# LAKE NONA MEDICAL ARTS

## SUMMARY

<p><b>Owner</b> Jim Leiferman, Manager One 80 Group, LLC</p> <p><b>Applicant</b> Scott Martin, VP Morris Architects, Inc</p> <p><b>Project Planner</b> Michaëlle Petion</p> <p><b>Updated:</b> November 7, 2014</p>	<p><b>Property Location:</b> 10298 Savannah Park Dr. (north of Moss Park Rd., south of Savannah Park Dr., east of Narcoossee Rd. and west of SR 417) (Parcel ID #08-24-31-9236-00-0001) (±7.12 acres, District 1)</p> <p><b>Applicant's Request:</b> The applicant is requesting Master Plan approval for a two-phase, 72,000 sq. ft. (total), medical office development on Parcel B of the Villages at Moss Park PD.</p>	<p><b>Staff's Recommendation:</b> Approval of the request, subject to the conditions in this report.</p>
---	--	--

DEVELOPMENT PLAN

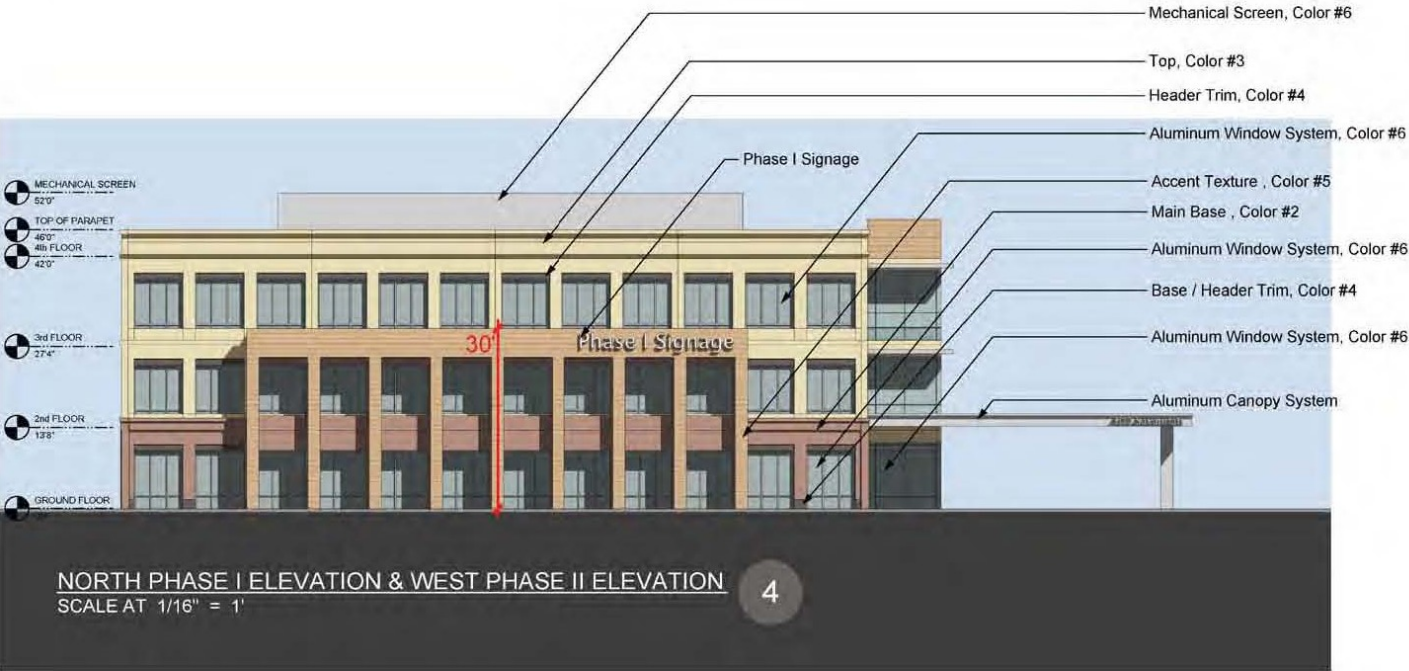
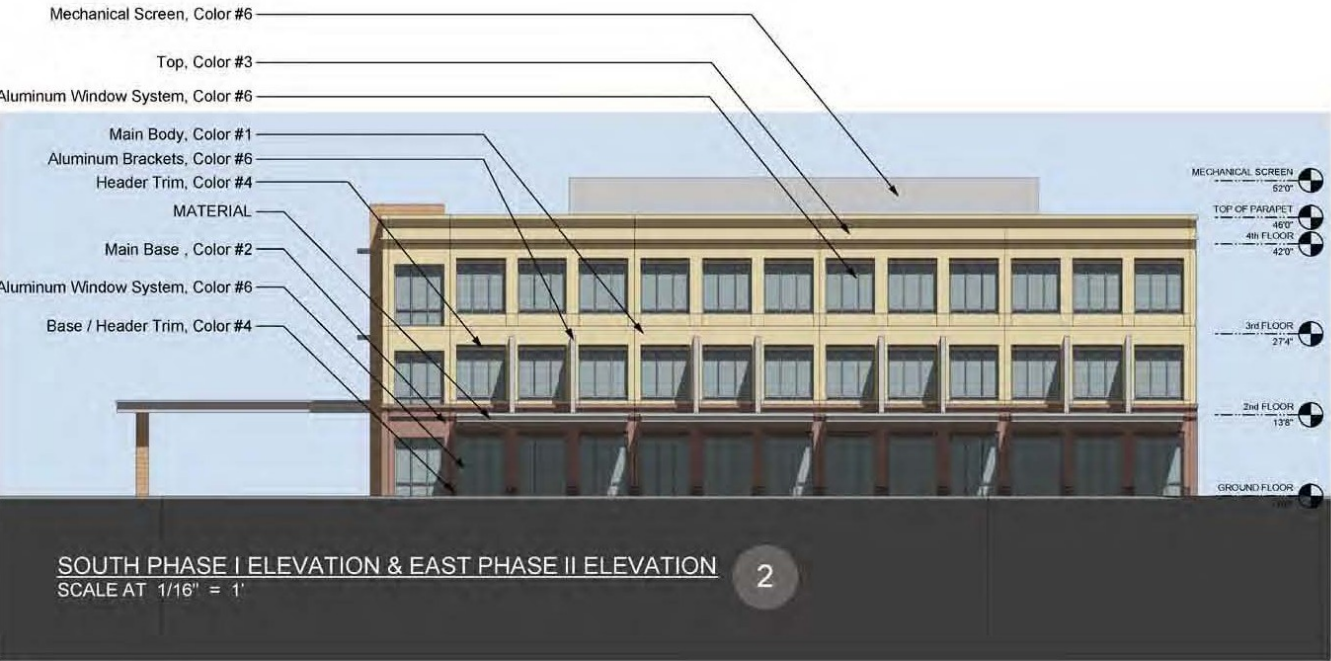
No structures are proposed in the rectangular portion of the site adjacent to the commercial outparcels.
